Form 3160-5 (August 2007)

Project: Lea County, NM (Nad83) Site: West Shinnery 15 Fed Well: West Shinnery 15 Fed 2H Wellbore: Wellbore #1 Plan: Plan #3 120511 Rig: McVay #8

West Shinnery 15 Federal 2H Devon Energy Production Company, LP 30-025-39956 8 Dec 2011 Conditions of Approval

1. To revise the planned well trajectory Drainhole Total Depth (DHTD) to be 75' from the original location.

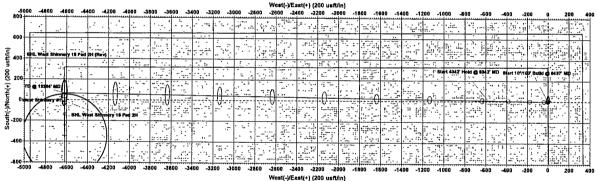
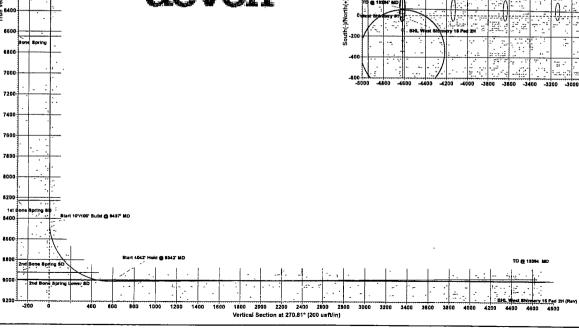
Please find attached the revise north 75' from the original loca	ed Directional Survey for ation. This was approved	the West Sh d on 11/18/10	innery 15 Fed 2F	1 moving the E	BHL				
Thanks in advance for your qu	lick response since Devo	on is currently	drilling this well.						
Approval Subject to Gene & Special Stipulatio	C	SEE ATTA ONDITIO	CHED FOR NS OF APP	ROVAL					
14 Thereby certify that the foregoing is	true and correct Electronic Submission # For DEVON ENEF	124971 verifie	d by the BLM Wel	I Information S	ystem				
	mitted to AFMSS for proc	essing by KUI	RT SIMMONS on 1	12/08/2011 (12K	•				
Name(Printed/Typed) MELANIE	A CRAWFORD		Title REGUL	ATORY ANALY	YST				
Signature (Electronic S	ubmission)		Date 12/06/20	011	AP	PROV	FD		
	THIS SPACE FO	OR FEDERA	L OR STATE	OFFICE USE					
Approved By			Title PETR	OLEUM	NGINE	C _R 8 2	011 ate	\neg

- a) A revised C-102 plat shall be promptly prepared and submitted.
- b) If needed, any necessary revisions in hole size / casing program must be submitted for approval in a separate sundry in advance.
- c) Subsequent sundries to be filed with drilling details to include all spud, casing and completion work.
- d) Completion report to be sent within 30 days of completion. Completion report to have all items completed.
